## **RRCS Health Facility, Section 75W application for modification (MP 08\_054, MOD 6)**

600-640 Victoria Road (also known as 59 Charles Street), Ryde

Environmental Assessment Report to

May 2013 | 0738

**Figure 1** – General Store/Medical Centre building envelope comparison (Approved PA and MOD 6) (approved envelope shown in red)

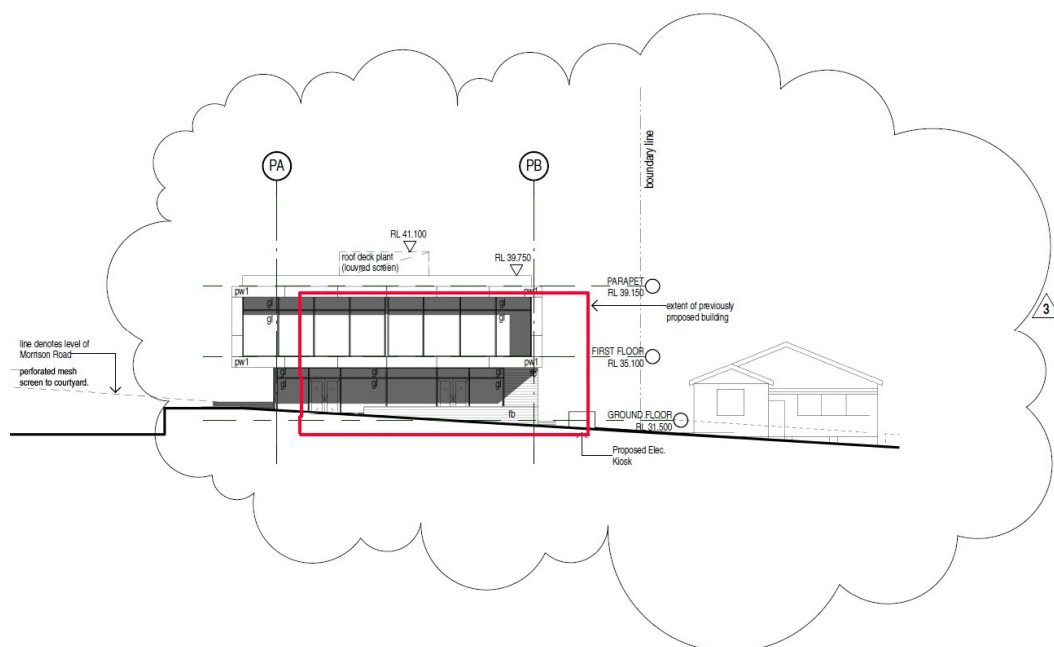
- (a) Revised General Store/Medical Centre Building including:
  - 950mm increase in building height (RL 38.80 approved and RL 39.750)
  - 160m<sup>2</sup> reduction in GFA (1,170m<sup>2</sup> approved and 1,010m<sup>2</sup> proposed)
  - Amended siting (including increased setback to eastern side boundary from 3785 mm approved to 6065mm proposed)

**Figure 1** compares the proposed General Store/Medical Centre building envelope with the approved PA envelope.
